Question #1: Is there a detail on manhole MH1?

Question #3: Plans call to splice 3/0 wire to 500mcm. Splices are standard 4/0 to 500mcm. Please advise.

112kVA Transformer at E&O Substation

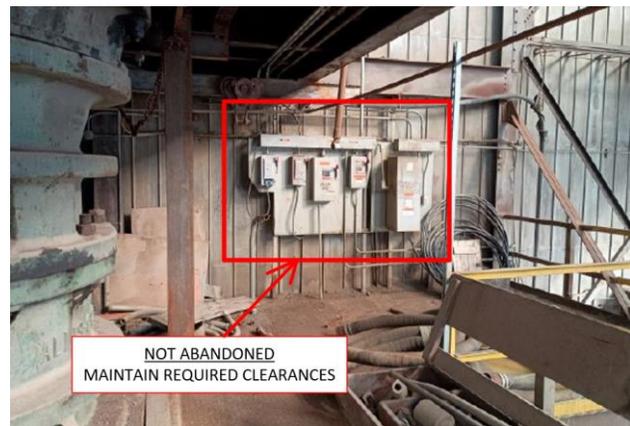
Question #8: Do any of the transformers that are to be demolished during Phase I contain PCBs?

Answer #8: Five out of the nine transformers identified for demolition have "PCB-free" stickers from testing performed by T&R Electric in the 1990s and early 2000s, and contractors may use those stickers to request the associated certified test reports. The remaining four transformers (pictured on Page 3) do not have documentation confirming PCB content below 50 ppm and were manufactured during a period when PCB-based insulating oils were commonly used. SDSTA will sample the insulating oil in these four units and have an off-site testing laboratory analyze the samples to determine their PCB concentration before demolition. For purposes of this proposal and the related construction contract, please assume all transformers identified for demolition are PCB-free. If testing later confirms PCB concentrations above 50 ppm, SDSTA will issue a change order to address the additional regulatory handling, transportation, and disposal requirements and associated costs.
